# Port Spencer Grain Export Facility

## Public Environmental Report

### Amendment to the Approved PER

Figure 1: Final proposed layout (Increased vehicle marshalling and expanded site)

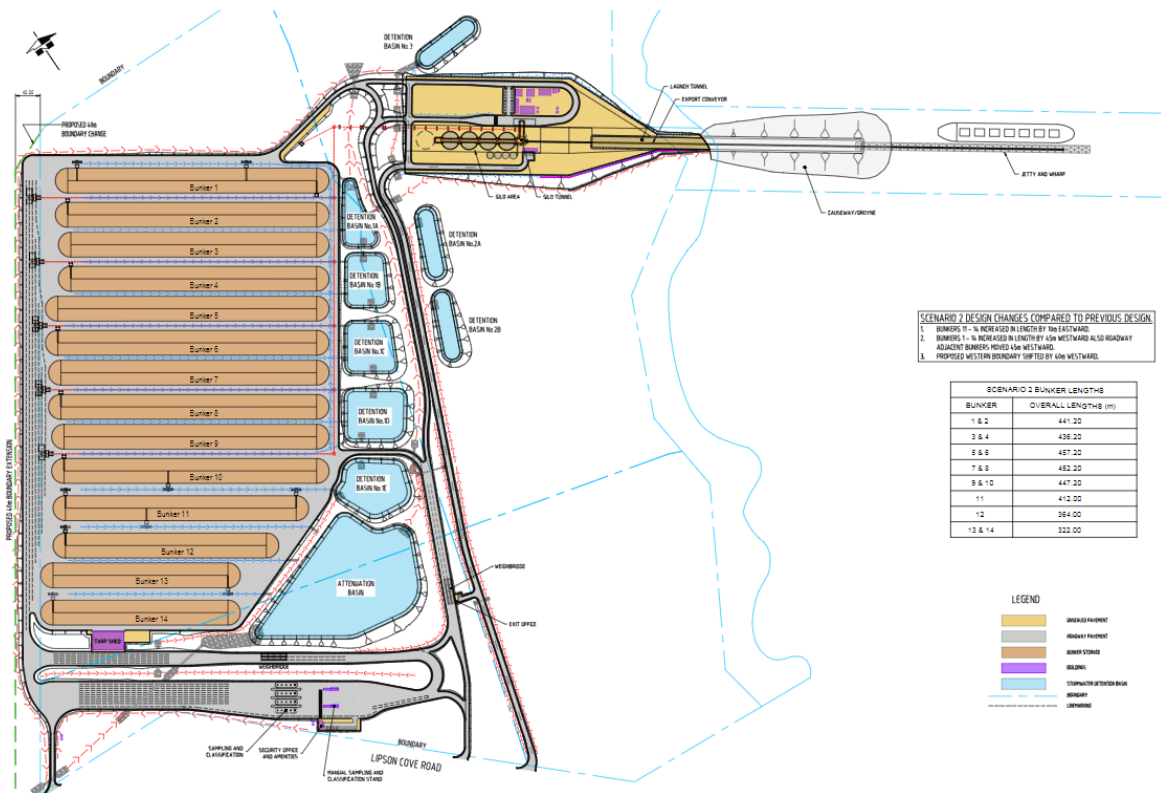
Marshalling space for 70 triple road trains is enabled through the re-orientation to an E-W bunker alignment and expansion of the marshalling area to the South end of the site. It represents an increase of 40-50 additional A-triple road train positions on site compared with the submitted N-S configuration.

Each of the fixed road hopper locations servicing conveyor systems on bunkers 1-10 is provided with an individual queuing lane, with a separate empty vehicle departure lane and a full vehicle bypass lane (enabling full vehicles to bypass the bunkers and go directly to the silo complex or exit the site). This increased number of lanes on the Western side of the site further reduces the risk of on-site congestion in addition to the increased marshalling areas. This extensive queueing facility shortens the effective bunker length in the E-W orientation, which is offset by the proposed 40m increase in length of the bunkers, described at Section 2 of this report.

Figure A1: Increased marshalling Vs. Approved design

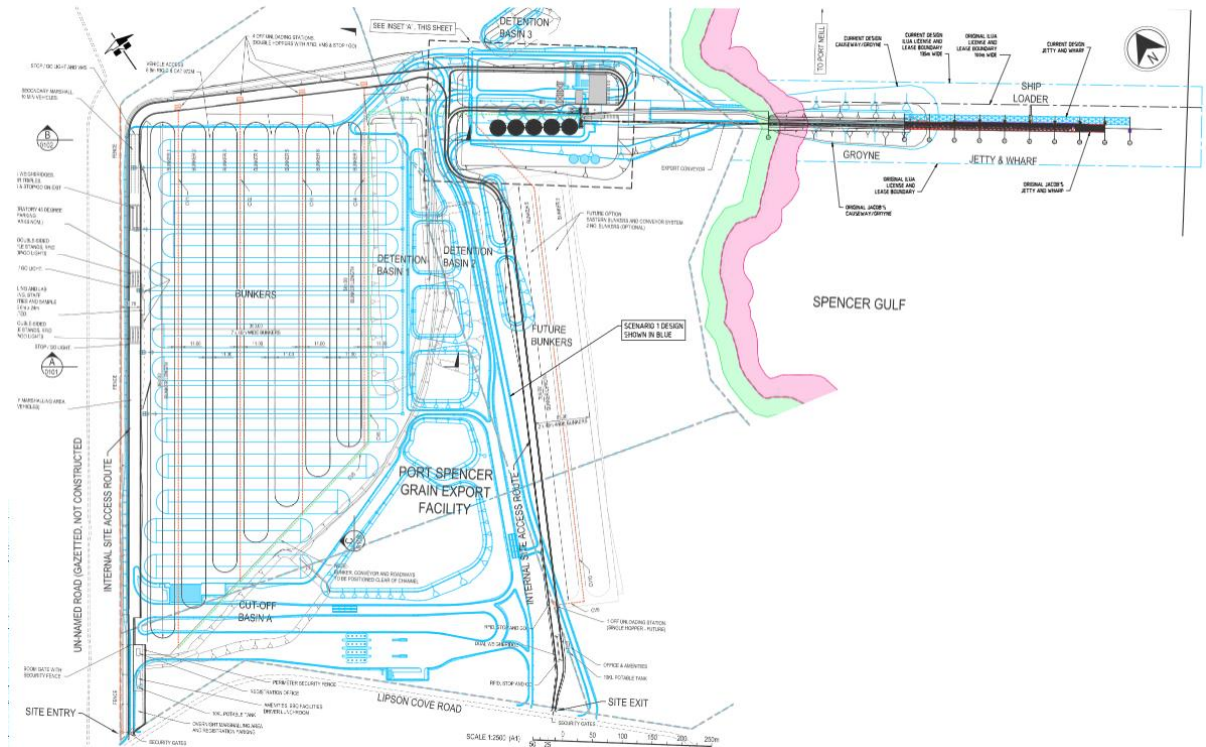
- Increased paved surface for **increased heavy vehicle marshalling**, with a resulting increase in stormwater management asset sizing, noting that the reorientation of grain storage bunkers from a N-S orientation to E-W (as generally described in the response document) was approved via the current authorisation;
- **Expansion of the project area** to include 40m of an adjacent road reserve on the Western and Northern boundaries of the site;
- Formalisation of the process of **staged submission** of construction issue drawings and other documentation **to demonstrate compliance with development authorisation conditions** in a staged manner in line with construction staging.

The alignment of the bunkers to an E-W orientation allowed a significant increase to on-site truck marshalling areas to further reduce the risk of heavy vehicles queueing onto Lipson Cove Road. It also allowed the noise and dust sources to spread over a larger area of the site rather than being more concentrated to the Northern area of the site.

Figure A3: Increased marshalling + expanded site area Vs. Approved design

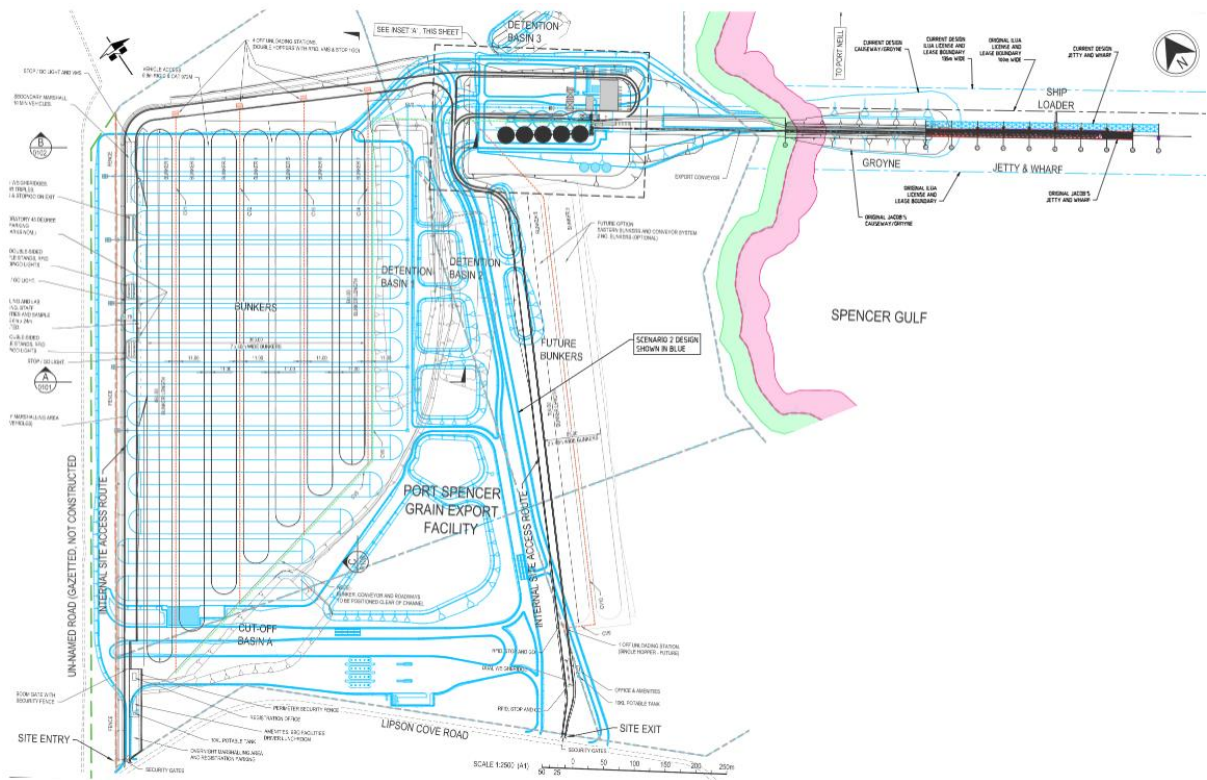
Based on retaining the required storage capacity the facility boundary utilises the 40m expansion to the west to provide the additional truck marshalling area at unloading points in front of the bunkers entrance and 40m expansion to the north to keep the total annual grain export capacity of the facility at the approved one million tonnes.

The change of expanding the site area to the North and West by 40m essentially brings the receptors 40m closer to the modelled emission sources. In considering the impact of the change, each receptor is assessed as being 40m closer to the relevant yellow output plot line from the modelling.

**PENINSULA PORTS**  
PORT SPENCER GRAIN EXPORT FACILITY, S.A.  
CIVIL WORKS  
**OVERALL SITE PLAN - (SCENARIO 1)**

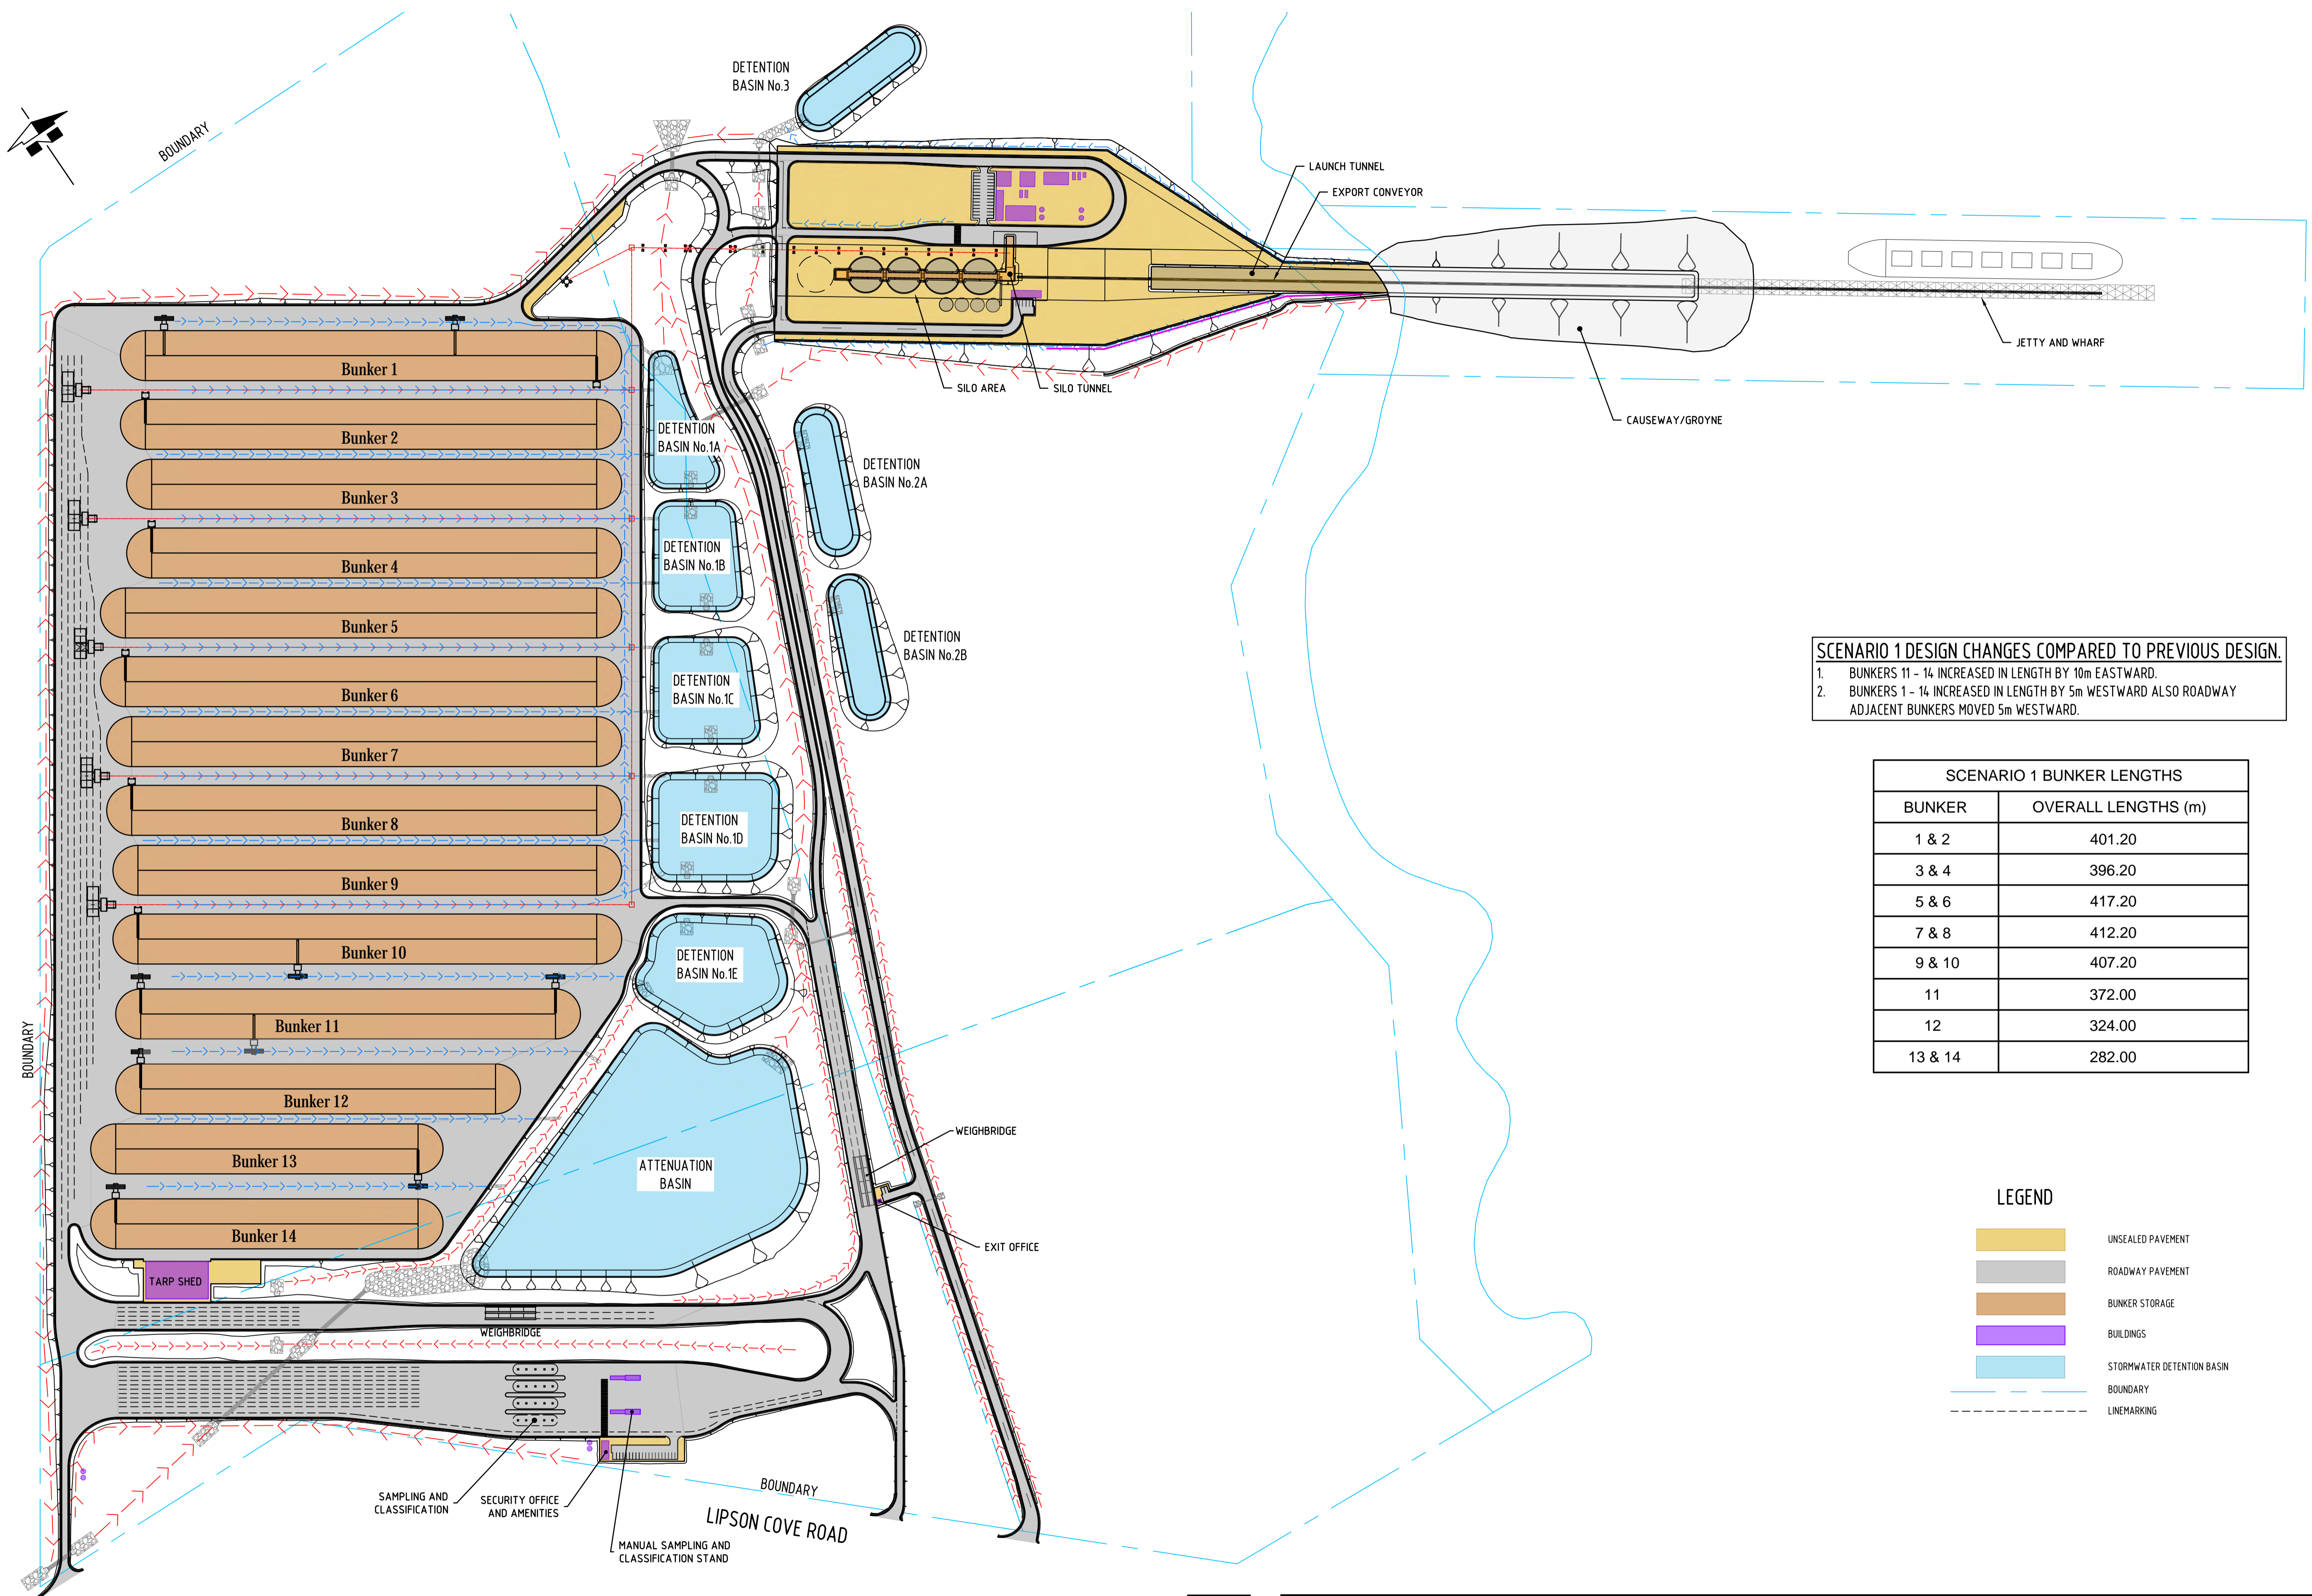
**SCENARIO 1 DESIGN CHANGES COMPARED TO PREVIOUS DESIGN.**

- BUNKERS 11 - 14 INCREASED IN LENGTH BY 10m EASTWARD.
- BUNKERS 1 - 14 INCREASED IN LENGTH BY 5m WESTWARD ALSO ROADWAY ADJACENT BUNKERS MOVED 5m WESTWARD.

**PENINSULA PORTS**  
PORT SPENCER GRAIN EXPORT FACILITY, S.A.  
CIVIL WORKS  
**OVERALL SITE PLAN - (SCENARIO 2)**

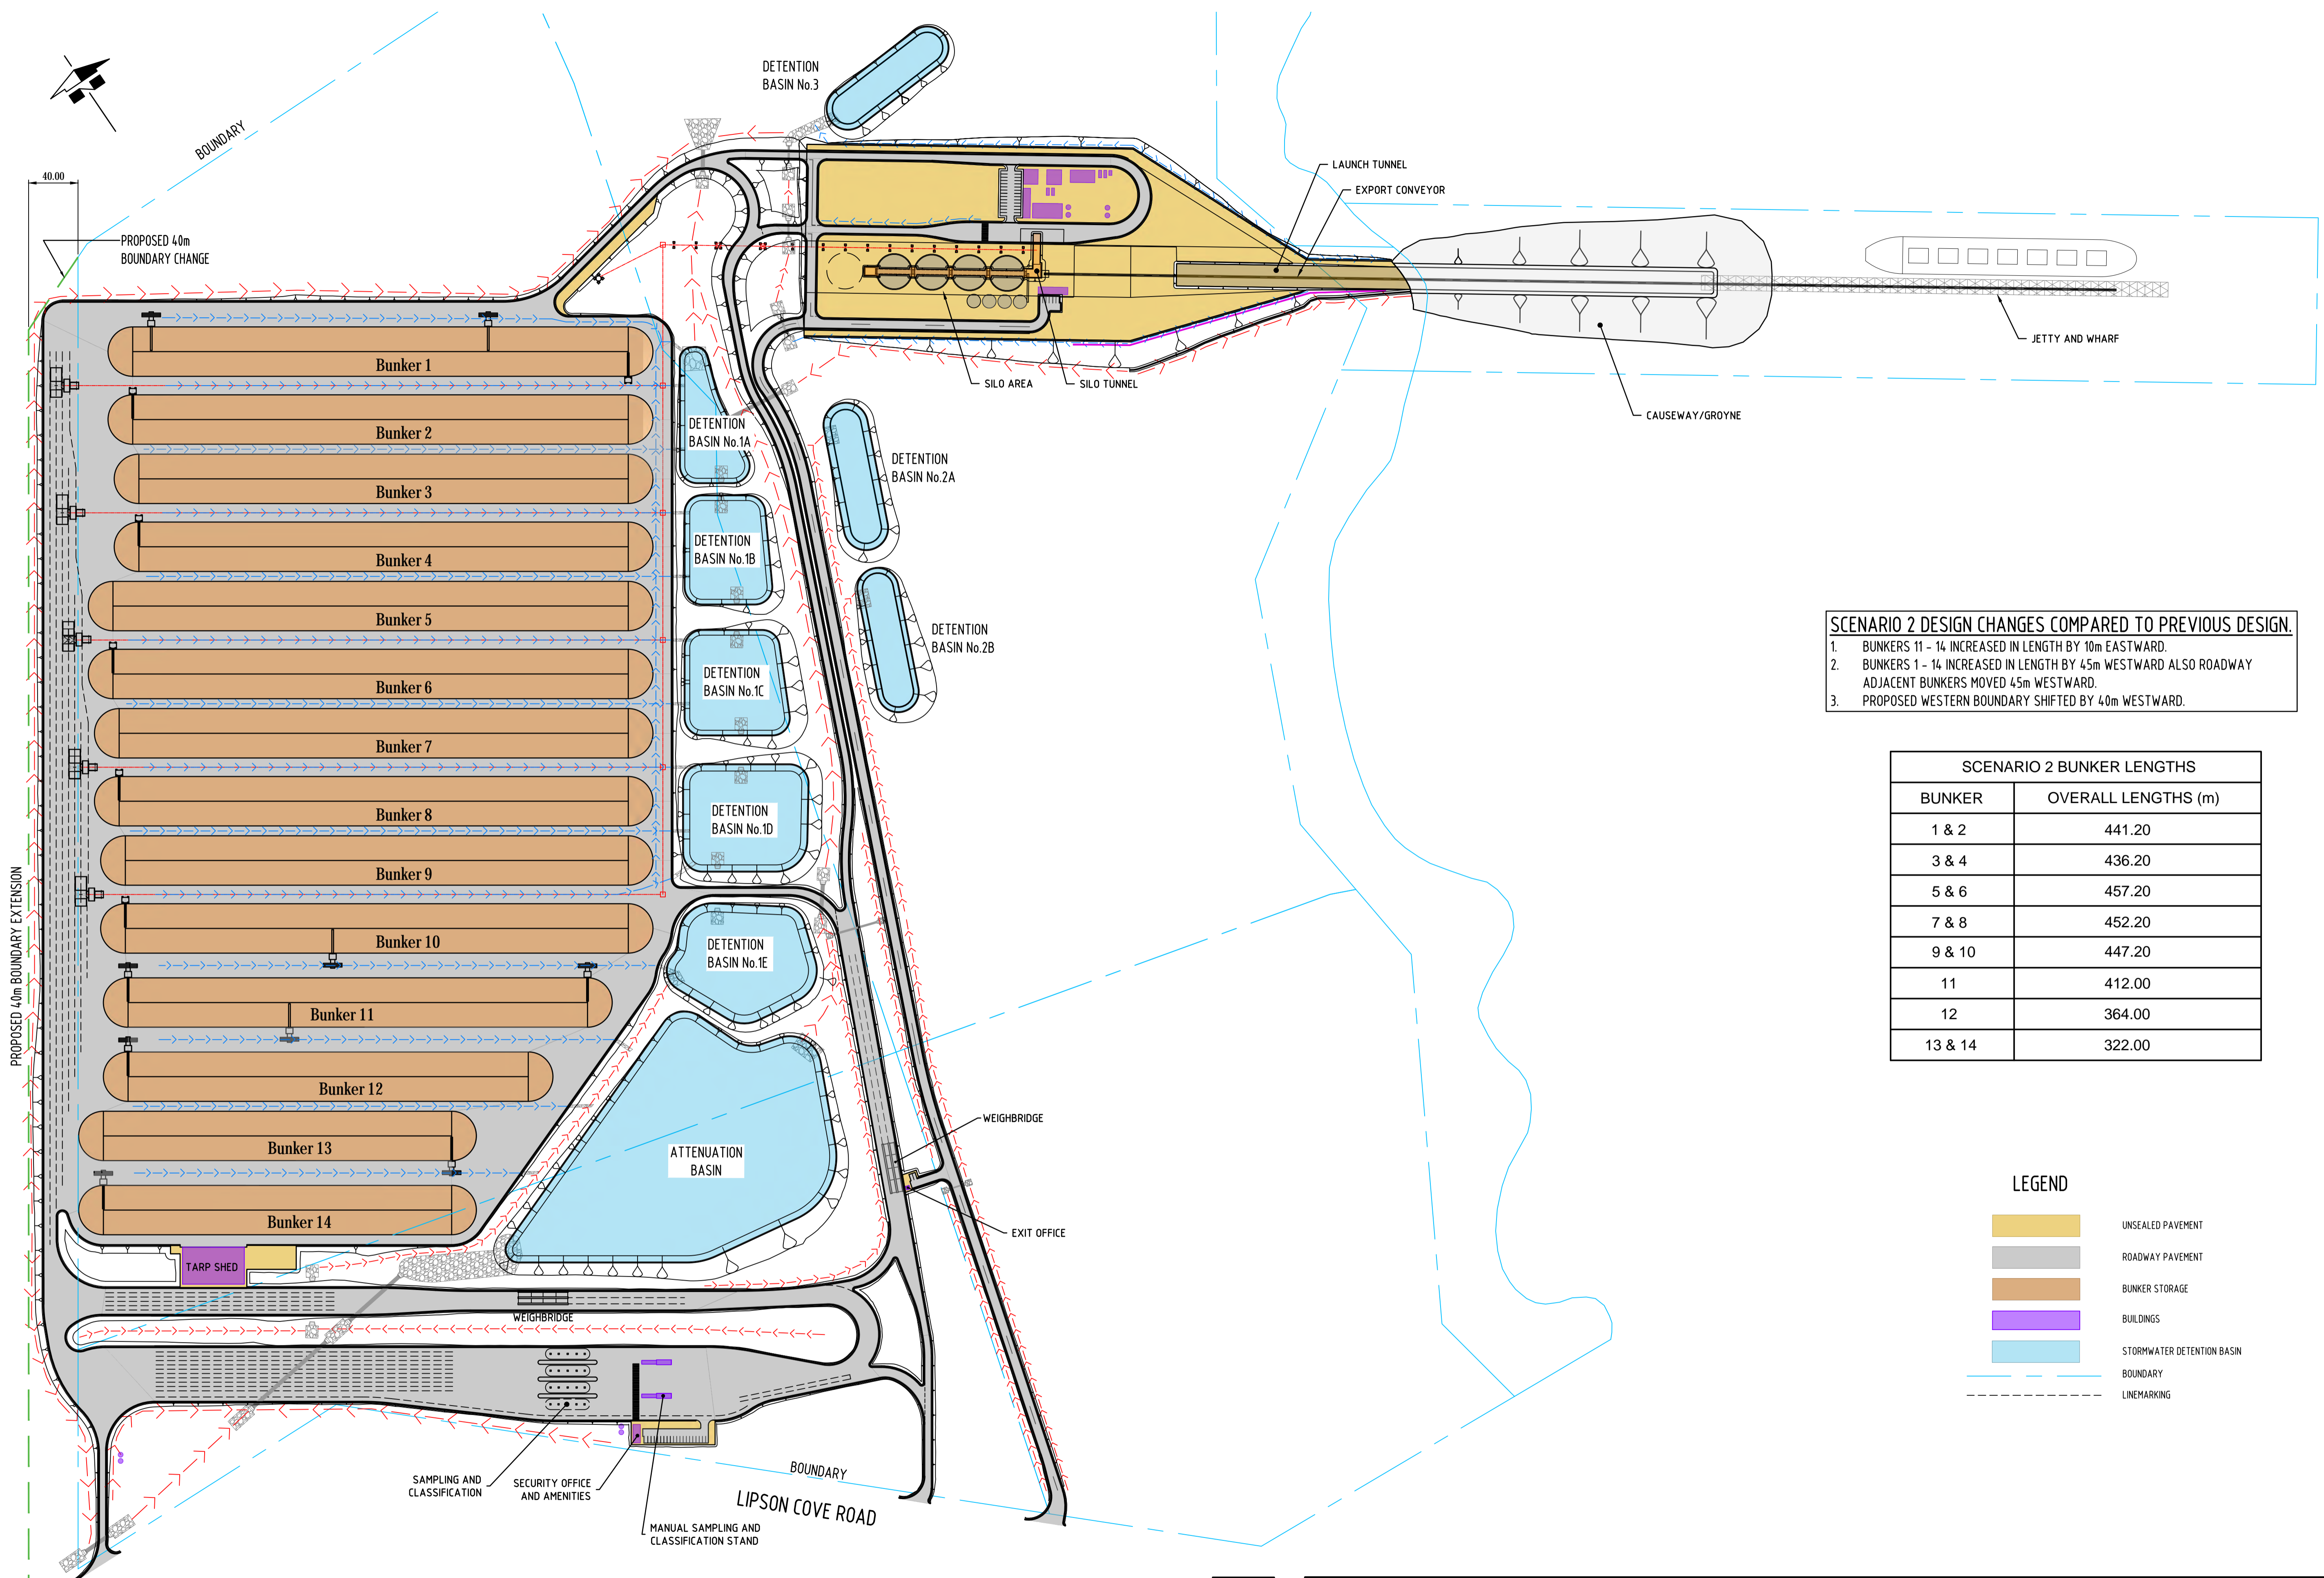
- SCENARIO 2 DESIGN CHANGES COMPARED TO PREVIOUS DESIGN.**
1. BUNKERS 11 - 14 INCREASED IN LENGTH BY 10m EASTWARD.
  2. BUNKERS 1 - 14 INCREASED IN LENGTH BY 45m WESTWARD ALSO ROADWAY ADJACENT BUNKERS MOVED 45m WESTWARD.
  3. PROPOSED WESTERN BOUNDARY SHIFTED BY 40m WESTWARD.
